CONTRACT CHANGE ORDER NO. _____
SHEET ____ OF ____

MARK	DATE	DESCRIPTIONS	BY	CH'D	CCO#
2	01/06/12	MISCELLANEOUS TRAVELER MODIFICATIONS	AS	JD	183S1
1	02/25/11	TRAVELER MODIFICATIONS	AS	JD	183

SAN FRANCISCO OAKLAND BAY BRIDGE
EAST SPAN SEISMIC SAFETY PROJECT
SELF-ANCHORED SUSPENSION BRIDGE
(SUPERSTRUCTURE & TOWER)

LINEAR ACTUATORS AND DRIVES-04

ACTUATOR DRIVE FOR M50 ACTUATOR

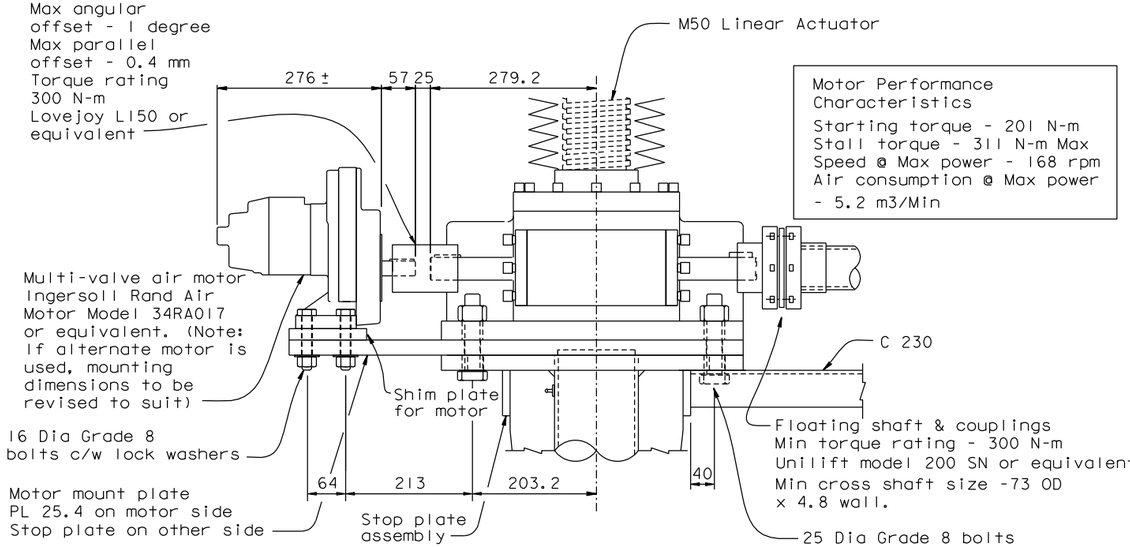
(See Note 1) 2

2 NOTES:
1. For modified anti-twist member and motor mount plate for M50 actuators, see "Linear Actuators and Drives-06" sheet.
